Subject: Solid Waste Authority of Palm Beach County
North County Resource Recovery Facility
Air Construction Permit/Title V Air Operation Permit Revision Application
RAI Response (File Numbers 0990234-012-AC and 0990234-013-AV)

This letter is in response to your request for additional information, File Numbers 0990234-012-AC and 0990234-013-AV Flares, Emergency Generators, and Landfill Gas Compression System. Our responses are as follows:

Subject: Solid Waste Authority of Palm Beach County
North County Resource Recovery Facility
Comments to Draft Air Construction Permit No. 0990234-012-AC and
Draft Title V Air Operation Permit No. 0990234-013-AV

ATTACHMENT 1

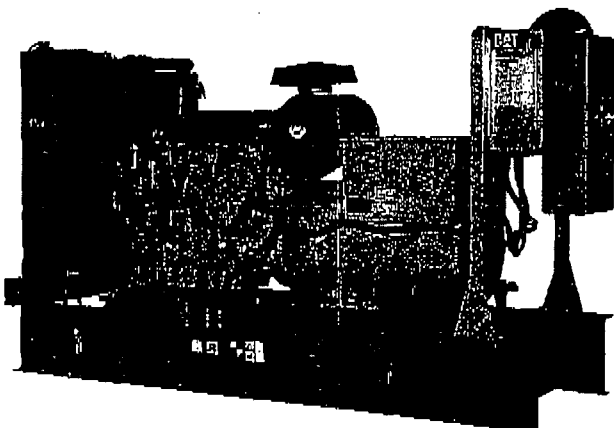
a. Are more recent sulfur content values available for the Class I and Class III landfill gases? If not, please obtain current values and report the results.

Facility Class I and III landfills was submitted in September 2007. This report included annual testing of the gases entering and exiting both the Class I and Class III flares. The values obtained for sulfur content were 290.5 ppm and 561 ppm, respectively. Updates to the calculations presented in APPENDIX E of the application have been included as Attachment 1.
